SUBJECT: Limerick Generating Station, Units 1 and 2
Draft Fire Protection Section of the
Safety Evaluation Report

Transmitted herewith are draft responses to open items which were transmitted by the reference letter. This material is provided in draft form at the request of Mr. Eberly, NRC staff reviewer. Final responses and any related FPER page changes will be submitted subsequent to the meeting scheduled for May 18 and 19, 1983 with the Fire Protection Section.

NRC Open Item #2: Fire Hazards Analysis

FIGURE B-21

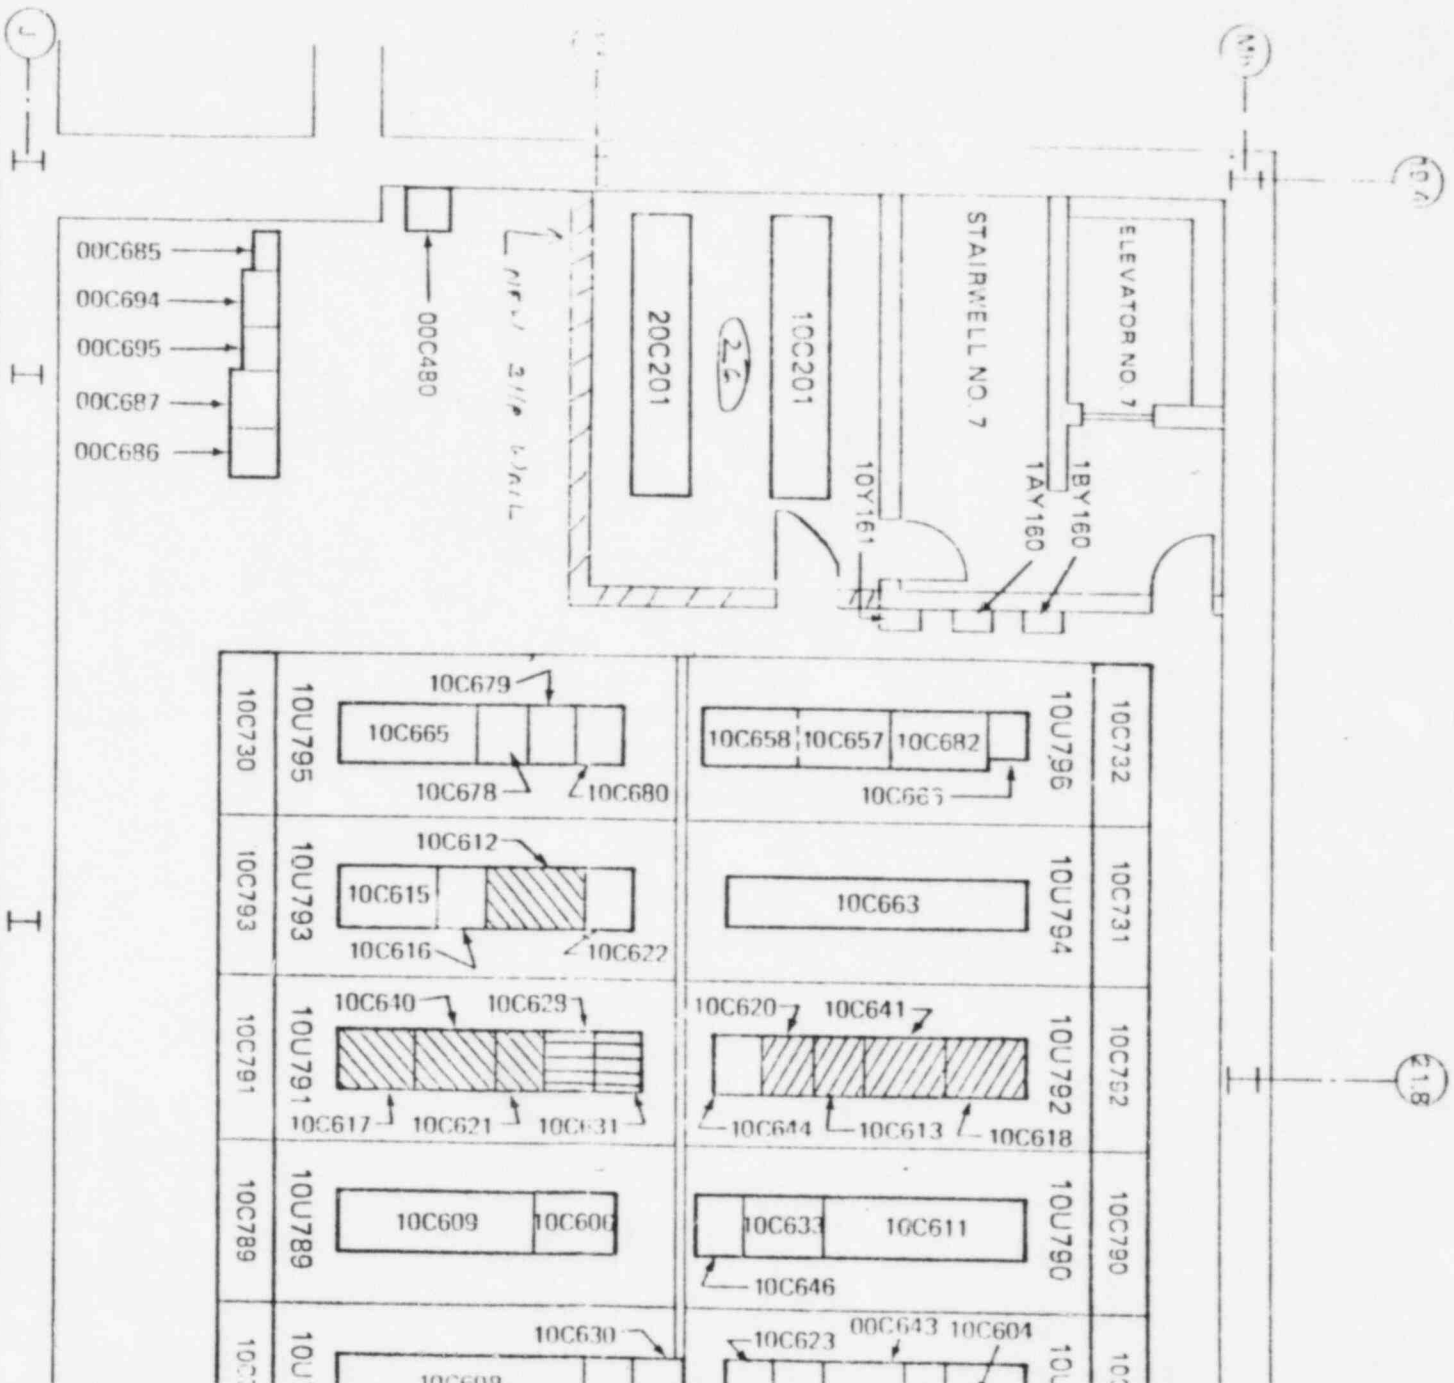
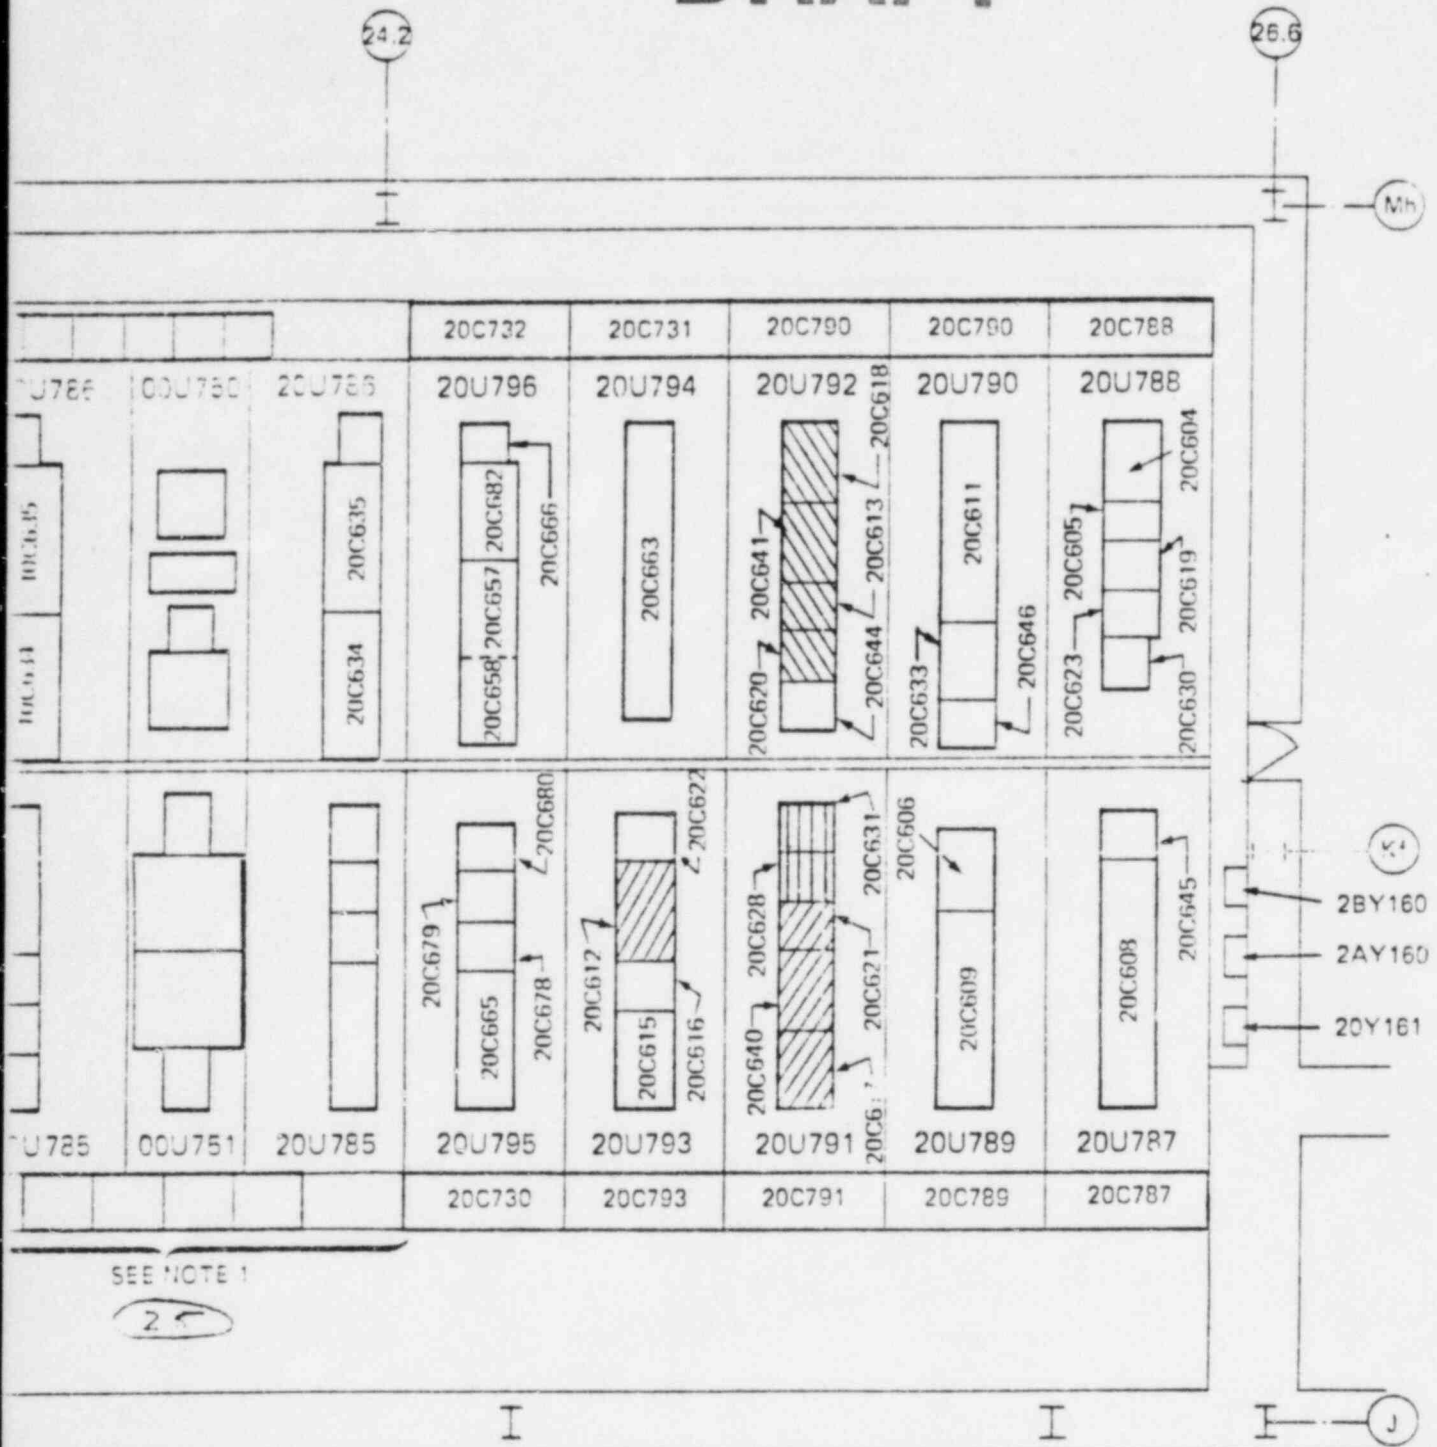
The applicant has not provided a description of the 2-hour rated fire barriers for the plant enclosed stairwells for us to independently verify compliance with our guidelines.

We require the applicant to provide details showing compliance with Section C.5.c of BTP CMEB 9.5-1.

Limerick will comply with the requirements of RTP CMEB 9.5-1, Section C.5.c, in Fire Area 25 and 26.

Drawings: FPER Figure B-21 (attached)

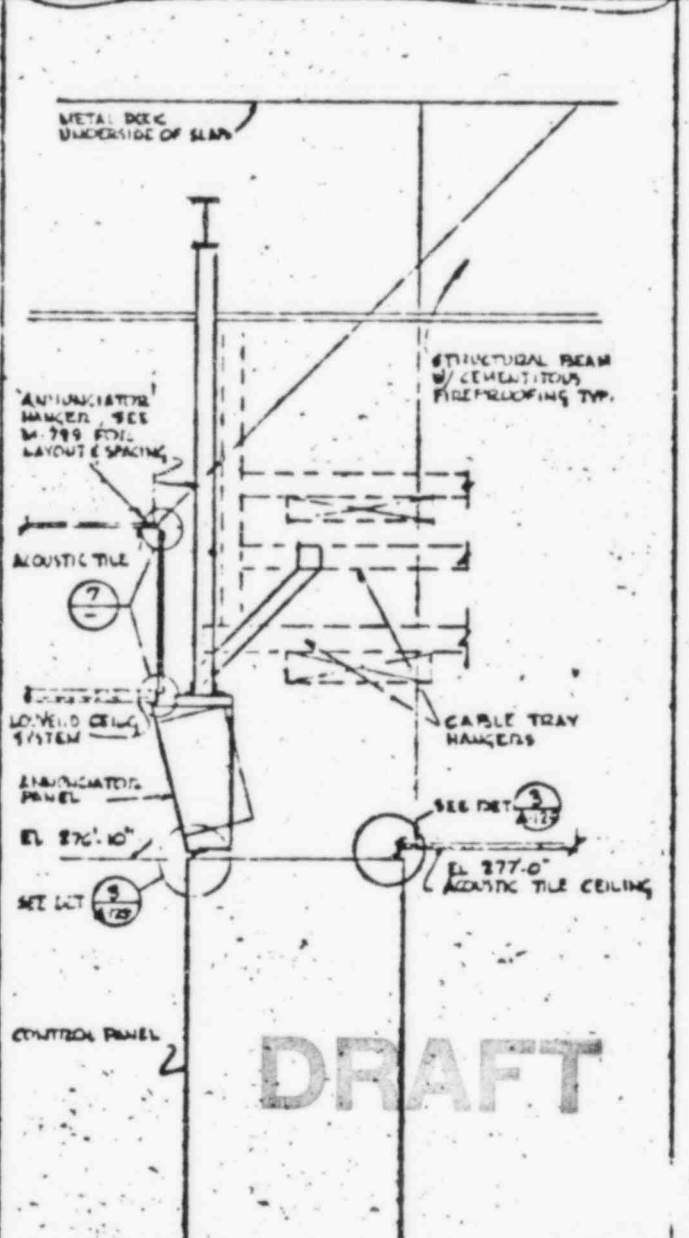
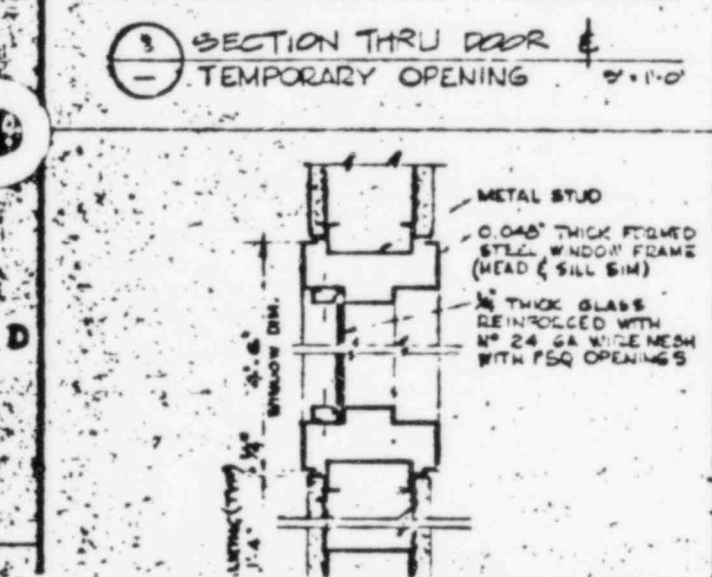
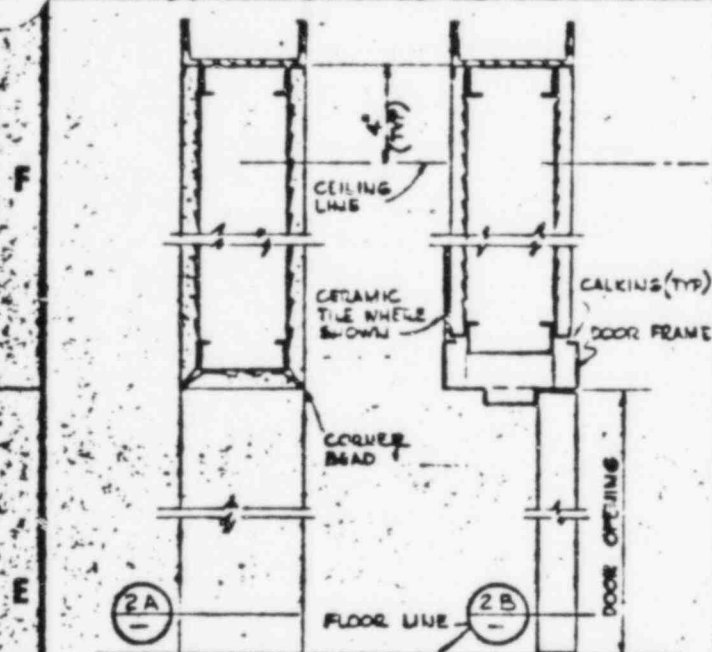
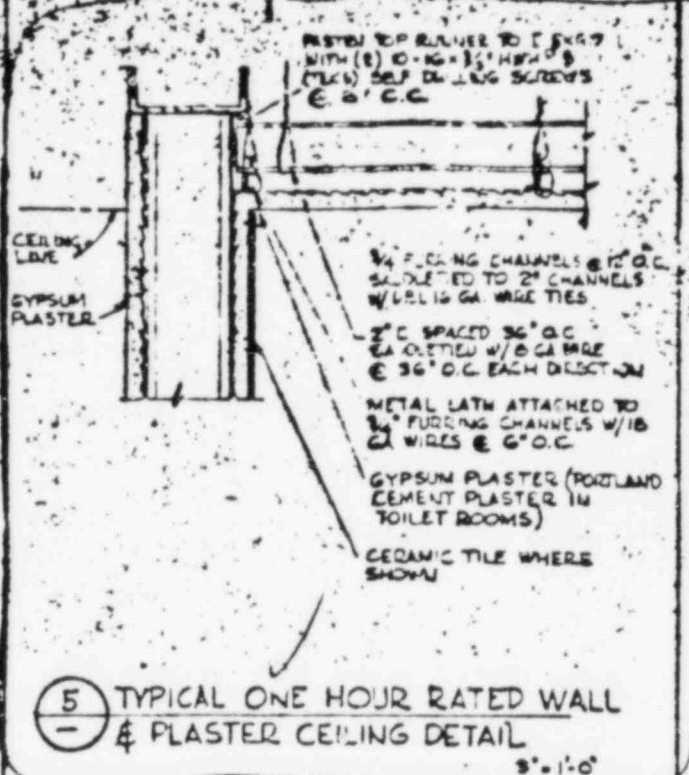
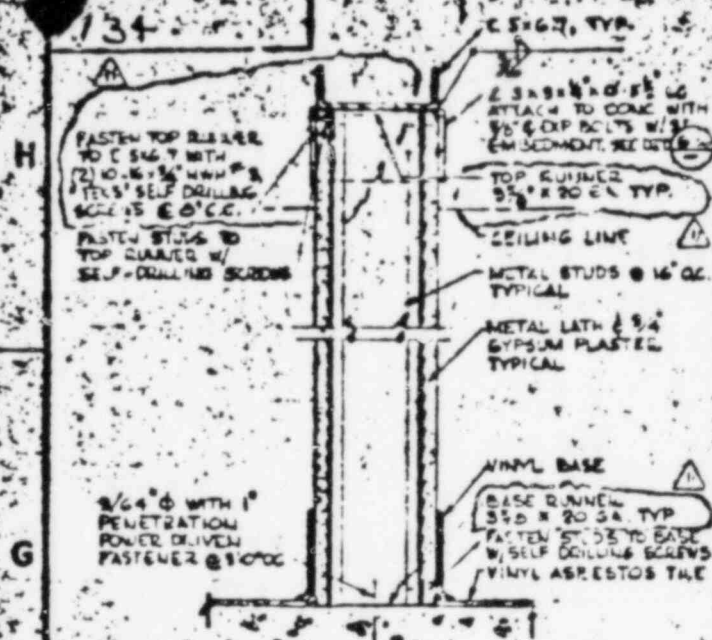
However, the applicant has not provided sufficient details of the control room complex for us to independently verify compliance with our guidelines.

We require the applicant to provide details showing compliance with Section C.7.b of BTP CMEB 9.5-1 of our guidelines.

Elevation 269'-0" of the control structure consists of the main control room and peripheral rooms, all contained within a 3-hr fire rated envelope, separating this portion of the structure from the rest of the plant.

All interior partitions are 1-hr fire rated, with exception of the shift supervisor's office, which has a glazed opening to enable observation of control room activities.
